Junee Subdivision

Recommendations Report

RES2305.40.115-RSA

1. Audit Response Statement

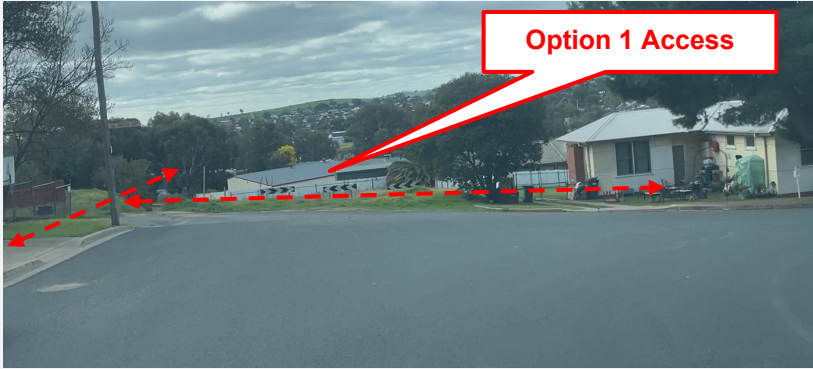
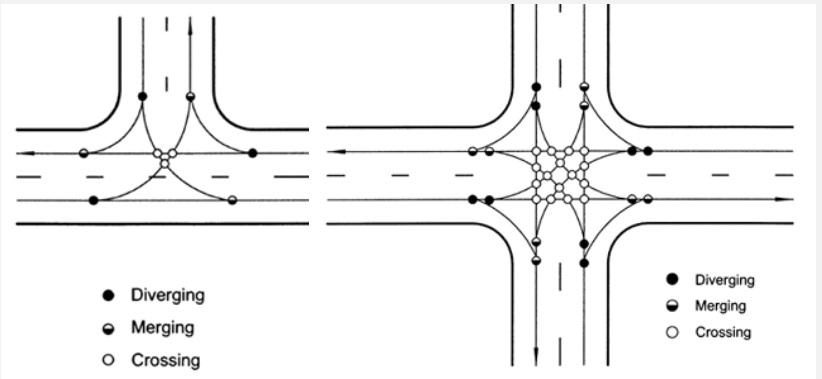
GE	General Observations	Photos / Reference	Recommended Actions
GE-6	<p>It is acknowledged that the provision of artificial lighting will form part of the development requirements. Consideration needs to be given to the adequacy of the existing lighting at the development access location adopted.</p>	 <p><i>Looking north down Kitchener Street at the proposed development intersection.</i></p>  <p><i>Looking southwest toward Option 2 access.</i></p>	<p>Consideration needs to be given to the adequacy of the existing lighting at the development access location adopted.</p>
